CONTROL ROOM DESIGN REVIEW

PRELIMINARY REPORT

Washington Public Power Supply System

WNP-2

PANEL P820

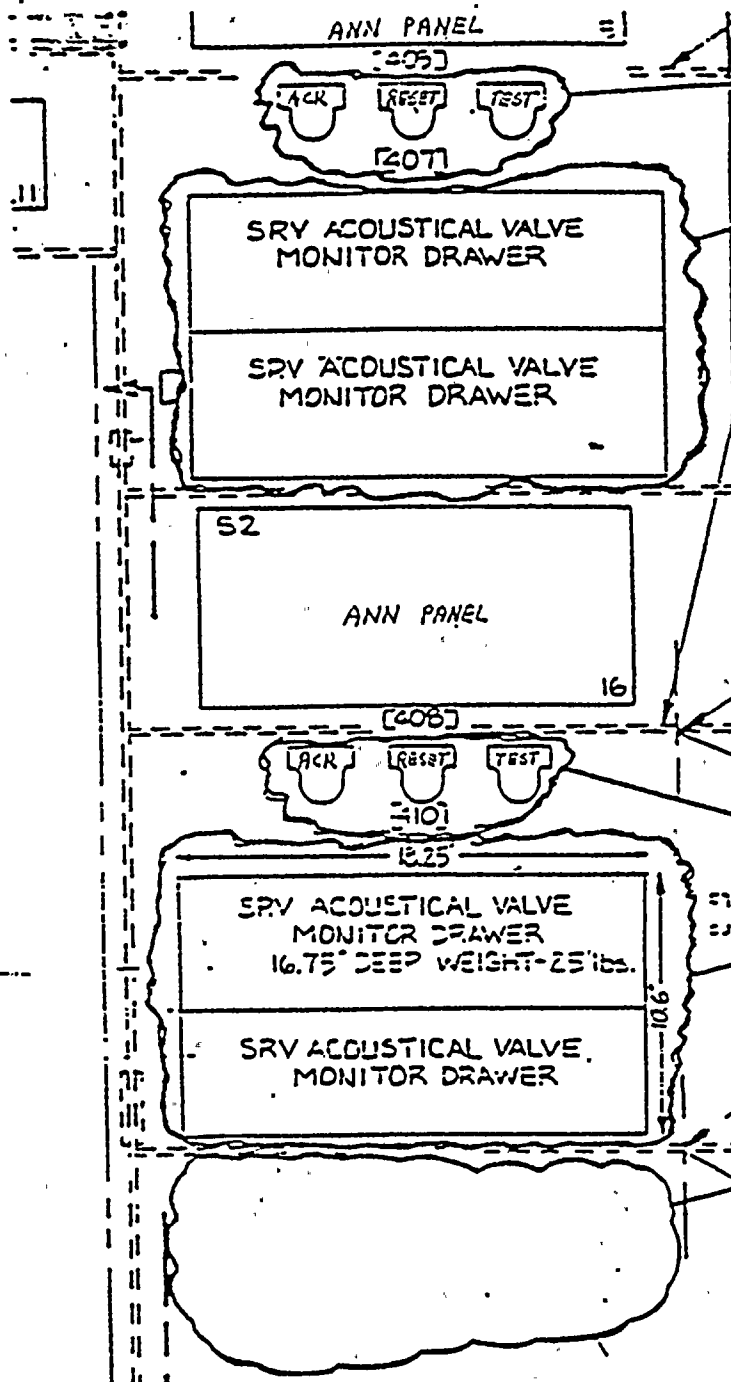
P851 System status monitoring panels SD-1, 2, and 3 are being deleted due to RG-1.47 redesign. The new SRV acoustic monitoring system subpanels will replace SD-1 and SD-2. This leaves the Division I and Division II annunciator panels and associated controls in a configuration that places the Division I

Revised location for S1 annunciator controls.

Existing Annunciator SD1 to be deleted by R.G.-1.47 changes. SRV Acoustical Monitors (R.G.-1.97) proposed location.
